Technical Assistance to Ohio Closure Sites

Recommendations to Address Uncertainties in Characterization and Delineation of Contamination at the Miamisburg Closure Project

**Miamisburg, OH
October 28-31, 2002**

Figure 2. Simplified cross section across the Mound Site (not to scale)

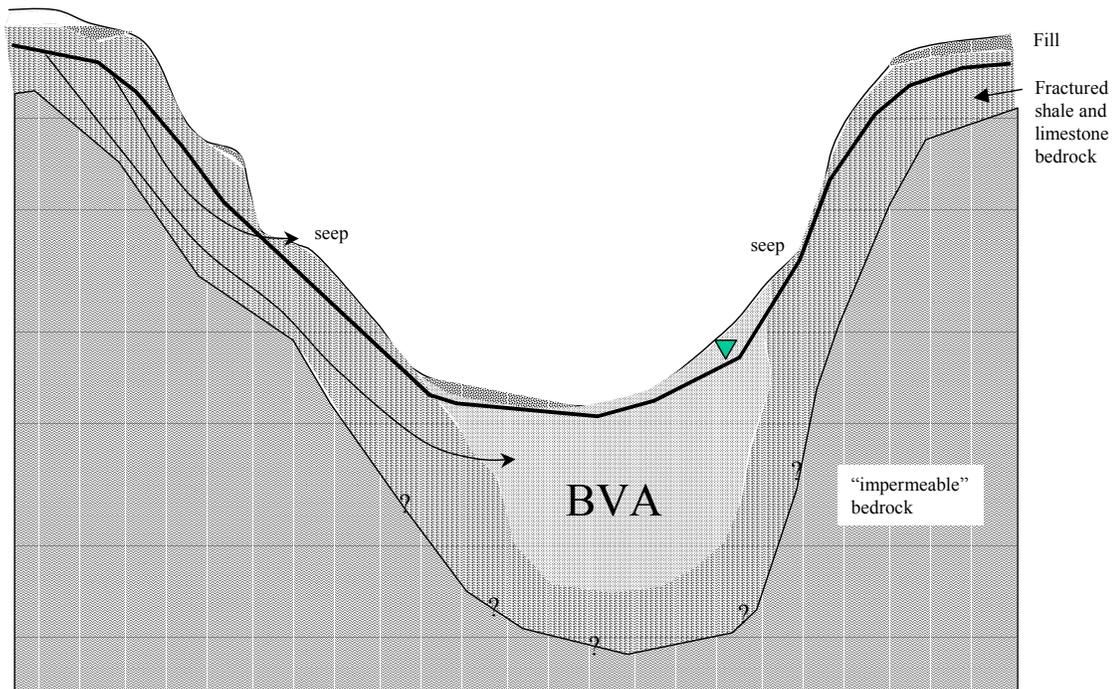
Water enters the subsurface of the Mound Plant primarily through recharge from rainfall. Over the years the amount and location of the infiltration has been modified by human activities. Buildings, roads, caps, and the like serve as a barrier to infiltration. Water in ditches and ponds will focus infiltration and anthropogenic water sources (leaking domestic and process water and fire lines) will modify flow patterns and accelerate flow through the system. Water entering the subsurface moves vertically in the vadose zone and into the water table. Once in the water table, flow is both lateral and vertical (downward) in recharge areas, eventually curving upward as groundwater drains to outcrops (seeps and surface water). Thus, in some areas flow trajectories will reach their maximum depths in the complex fractured rock zone (but limited by the relatively impermeable underlying bedrock). These deeper flow paths are generally toward local seeps and may reach the BVA and ultimately the Great Miami River. In areas near the hill margins, flow will be more local – toward local seeps – and entirely in the fractured aquifer zone and unconsolidated fill and BVA sediments. From a site-wide perspective this subregional flow appears radial toward the receiving seeps. Opportunities suggested by this conceptual model include:

- Overall plume migration can be reduced by relatively low cost modification of large scale hydrologic driving forces.
- Monitoring can be optimized based on the expected three-dimensional plume structure.
- Transient groundwater impacts from mobile contaminants currently in the vadose zone beneath building vadose can be minimized by maintaining infiltration-limiting covers and/or amendments to backfill to stabilize residual contaminants.
- Groundwater flow direction and rates of flow will be altered significantly and dynamically during building removal, slab removal, pipe removal, backfilling, and more frequent monitoring of hydrological parameters and frequent updating of flow paths to downgradient wells and seeps.

Figure 4. Conceptual depiction of flow lines around a building slab (A), and changes associated with removal of buildings and slabs (B)

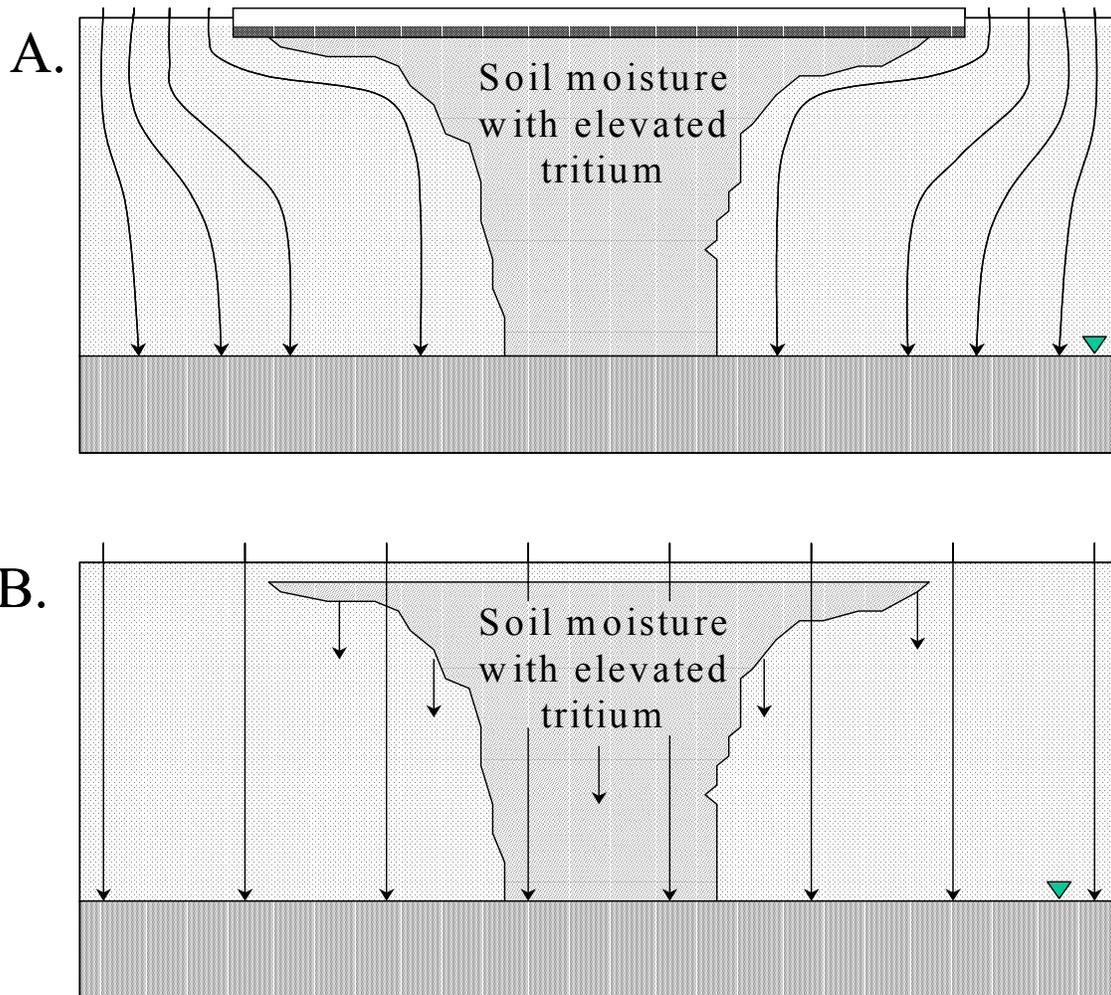
- There is a potential for transient tritium impacts to groundwater and downgradient seeps during building demolition as shown in Figure 4 (on page 26). The figure shows typical flow lines before and after a slab removal. Importantly, the vadose zone will be relatively dry so the potential for transient tritium transport to the groundwater may be best viewed as one of total activity (Bq or Ci) rather than “concentration” (Bq or Ci per L of soil water).
